DATE: August 2, 2022

**TO:** Mayor Andre Dickens, City of Atlanta  
**ATTN TO:** Monique Forte, Planner III, City of Atlanta  
**FROM:** Mike Alexander, Director, ARC Center for Livable Communities  
**RE:** Development of Regional Impact (DRI) Review

**Name of Proposal:** 990–1008 Brady DRI 3674

**Description:** A DRI review of a proposal to construct a mixed–use project on a 3 acre site on the west side of Brady Avenue north of 10th Street in the city of Atlanta. The project will include approximately 700 multifamily residential units, 300,000 SF of office, and 50,000 SF of ground floor retail around an open courtyard above an underground parking garage.

DRI SITE PLAN - SERVICE LEVEL

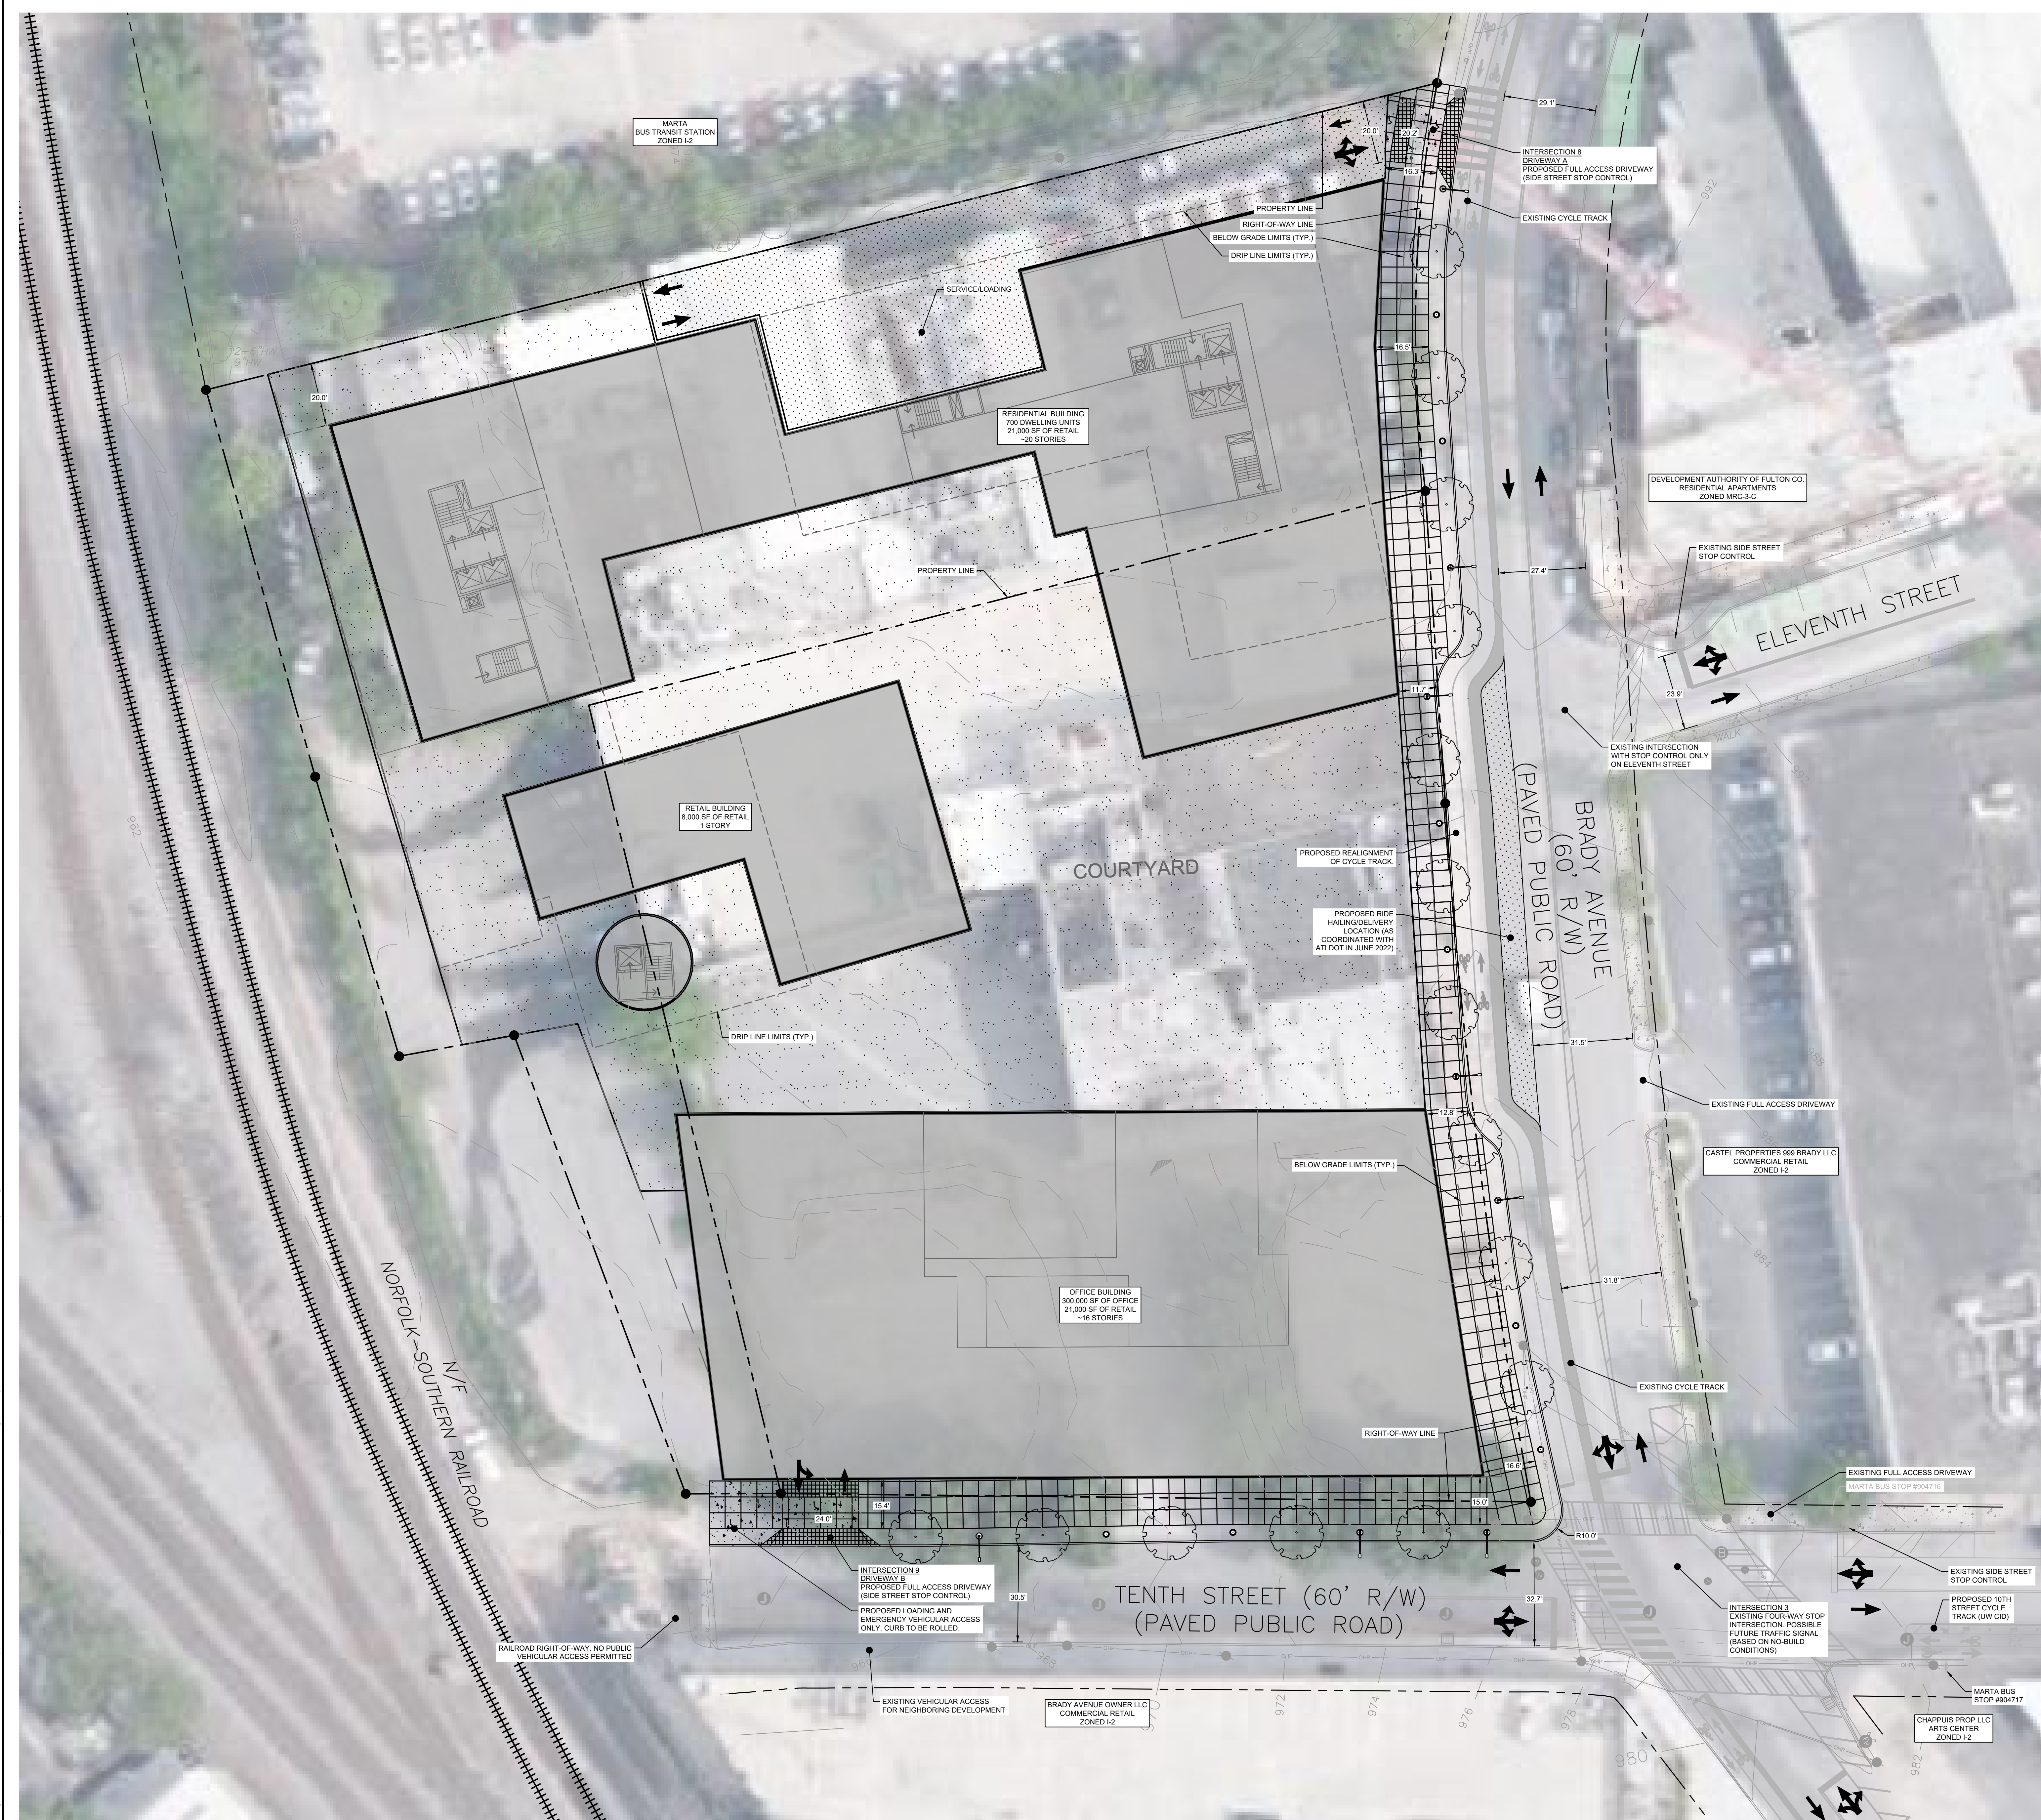
- The curves in the on-street bike lanes / cycle track to accommodate the pickup dropoff zone are too sharp. The horizontal lane shift is 10-11' so the taper length should be 7:1 or 70-77' in length to accommodate a bicycle design speed of 20 mph. Refer to AASHTO Guide for the Development of Bicycle Facilities, latest edition for further guidance. Adjust the site plan and streetscaping for a smoother facility transition.

- Bus Operations staff recently raised concerns about operating along the southbound lane of Brady Ave, due to the narrow lane width. It's imperative that we don't have anything even partially impeding these lanes.

- Route 26 has a bus stop pair at the intersection of Marietta St and Brady Ave.
- Question regarding the demolition and construction: will there be any disruption to traffic, bicycle or pedestrian flow along Brady Ave during either construction or demolition (such as construction cones or fencing)? The travel lanes along Brady Ave are extremely narrow and it would likely be impossible to have buses operate on these lanes if there are any intrusions close to them.
